Route Feasibility & Cable System Design Review

South Wokingham 132 kV & 33 kV Cable Connection

Doc. EC010-SS-REP-001

Figure 1 – Indicative Route Alignment & Joint Bay Positions

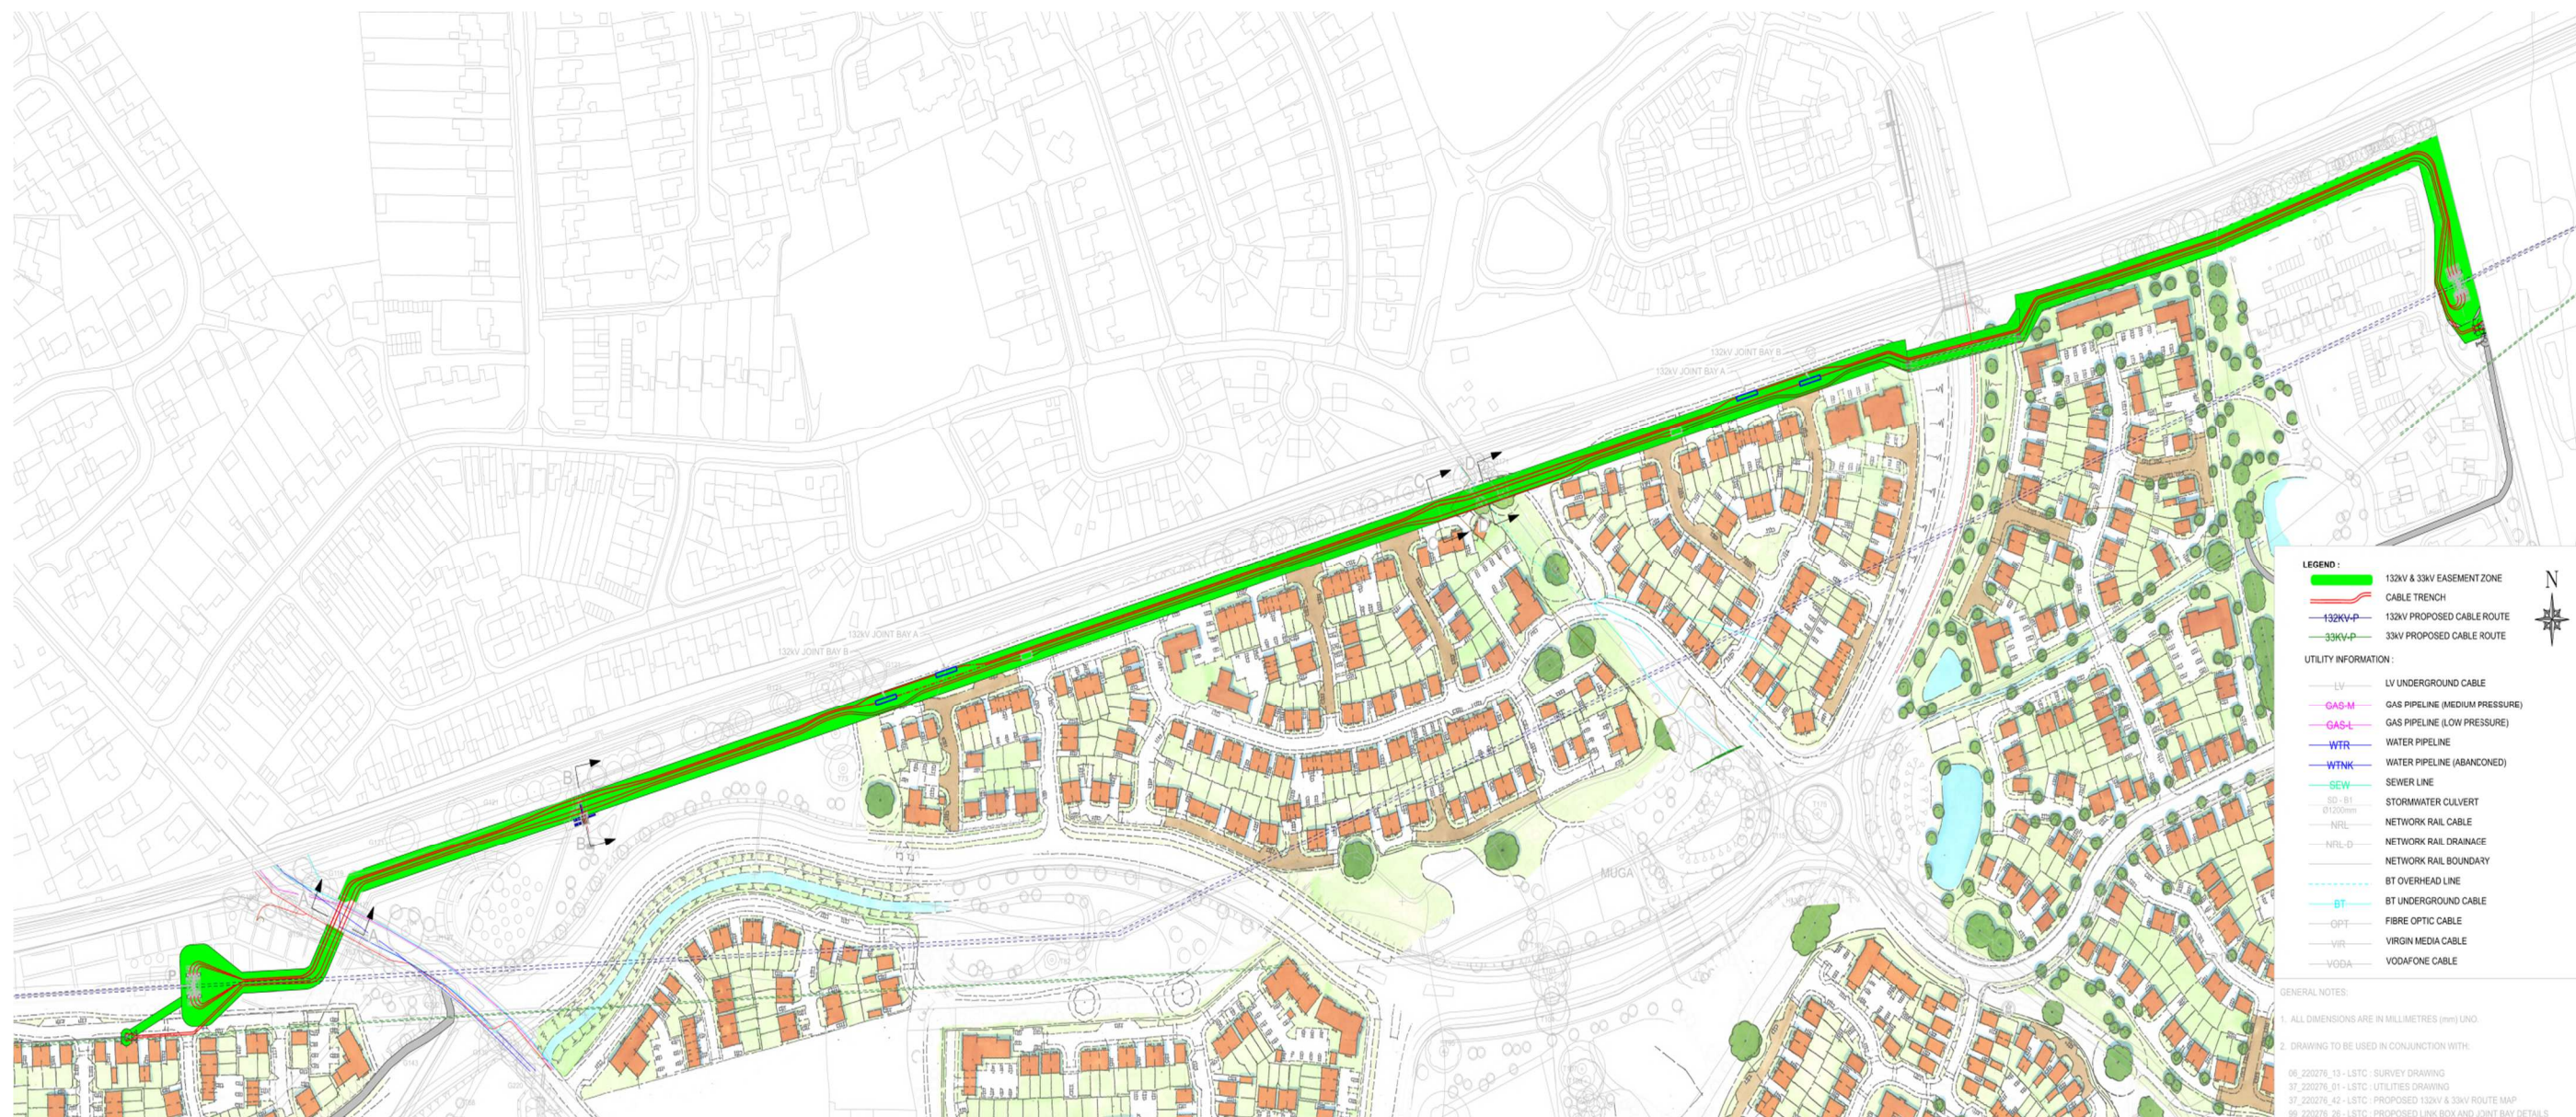
37_220276_42, Rev.A2, however they may need adjusting to avoid tree protection zones (see 8.5 below). We have estimated cable section lengths from the layout, however those remain to be confirmed. A sheath voltage calculation is provided in document EC036-SS-CA-300 which indicates the resulting maximum sheath voltages under normal operating conditions would remain well within the ENA C55 limit of 65V.

- ADAS to review the options for reducing the RPZs at T74, T75 and T78 to provide for a compliant cable system design in that area.
- SSEN to consider moving the 132 kV joint bays 1A and 1B slightly to the east to avoid the area where the easement will be constrained by RPZ's T75 and/or T78 (depending on the option chosen by ADAS above)

Figure 2 – RPZs proposed for T74, T75 & T78

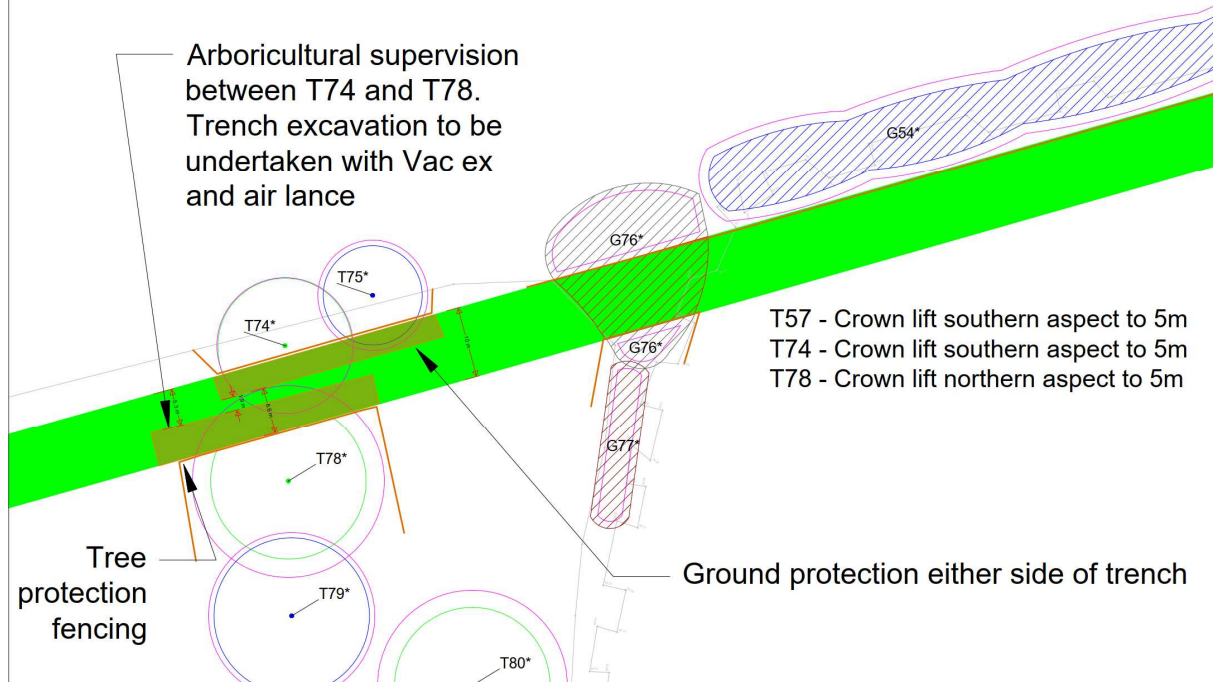
Section D-D should allow for RPZ G66 and G72 to be retained as planned by ADAS. However, some adjustment of RPZs T74, T75 and T78 will be required. Two options are proposed for ADAS review:

Option 1: Retain the RPZs for T74 and T75 and then cut back the RPZ for T78 to within 1.5 m of the edge of the easement to create a 5 m corridor. I assume this would impact the size of T78 and may restrict it's future growth?

Option 2: Remove tree T74 and make only minor adjustments to the RPZs for T78 and T75 to achieve a clear 5 m corridor for the cable route. We hope this would minimise any impacts on T74 & T78.

Figure 3 – RPZs proposed for G66 & G72

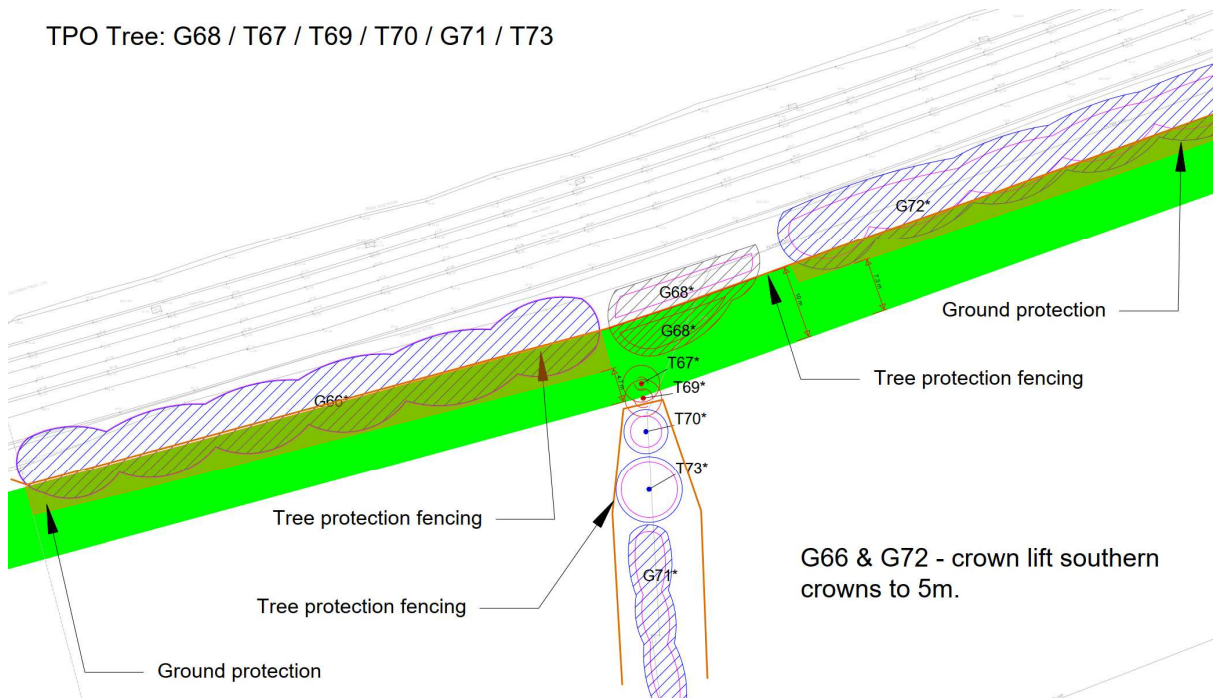
5	Root Protection Zones for G66 & G72	Cable trench cannot overlap RPZ owing to risk of soil dry-out or future root growth damaging the backfill. Cable trench design is proposed for use within limited corridor that	M	Implement measures to ensure that RPZ does extend into easement any more than indicated in drawing ADAS_1052383-018 at any time within cable asset life (40 years).

Any RPZs that are retained adjacent to the cable trench must be designed or maintained to ensure that future root growth will not encroach into the easement beyond the edge of the RPZ as marked on drawing 'ADAS_1052383-018'. This is necessary to ensure the circuit ratings and asset reliability will not be compromised.

Figure 4 – Pre-installed ducts for 132kV cables under William Helas Way

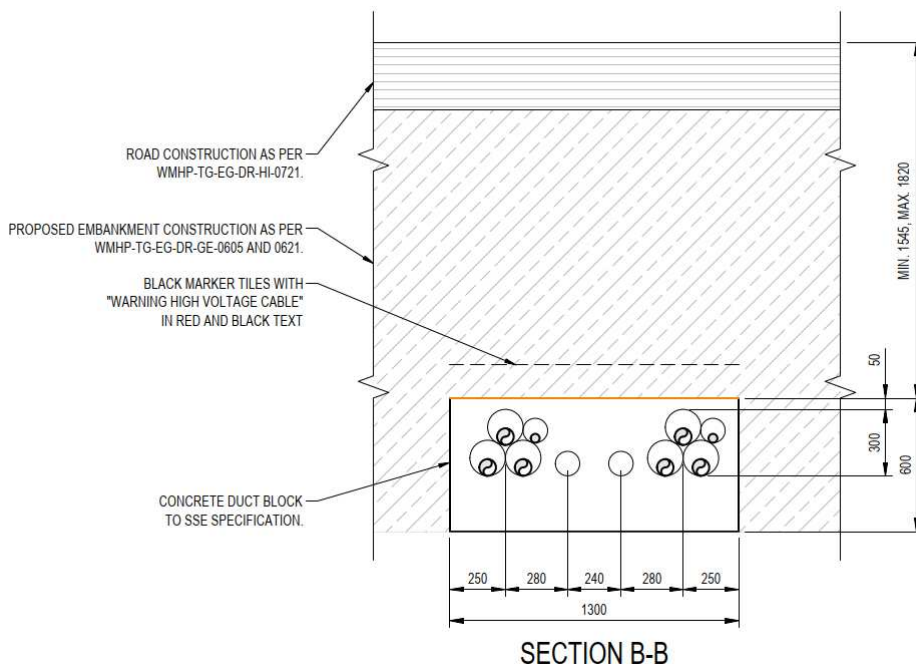
Installations arrangements for both the 132 kV and 33 kV cables have previously been designed for the crossings of William Hells Way. Ducts were proposed for the 132 kV circuits under the road and it is understood that these are already installed as detailed in Balfour Beatty drawing WMHP-TG-EG-DR-DD-0551 rev.C02 and copied in Figure 4. That arrangement is considered suitable for compliant design and ratings, however the use of 160 OD ducts will need to be accommodated in the cable pulling method.

The proposed HDD for the 33 kV circuits would be compliant for ratings if installed with 800 mm² Aluminium cables, provided the physical separation between the HDD and the 132kV road crossing is sufficient to provide thermal independence. That separation is not clear from the drawings supplied and will need to be assessed in the ongoing design development.

- Undertake an assessment to verify the HDD proposed under William Helas Way would be thermally independent of the 132 kV cables at the road crossing.
- The cable installation contractor should be required to undertake surveys of the pre-installed ducts under William Helas Way (for both 132 kV and 33 kV circuits) to ensure they are intact and clean prior to cable pulling.
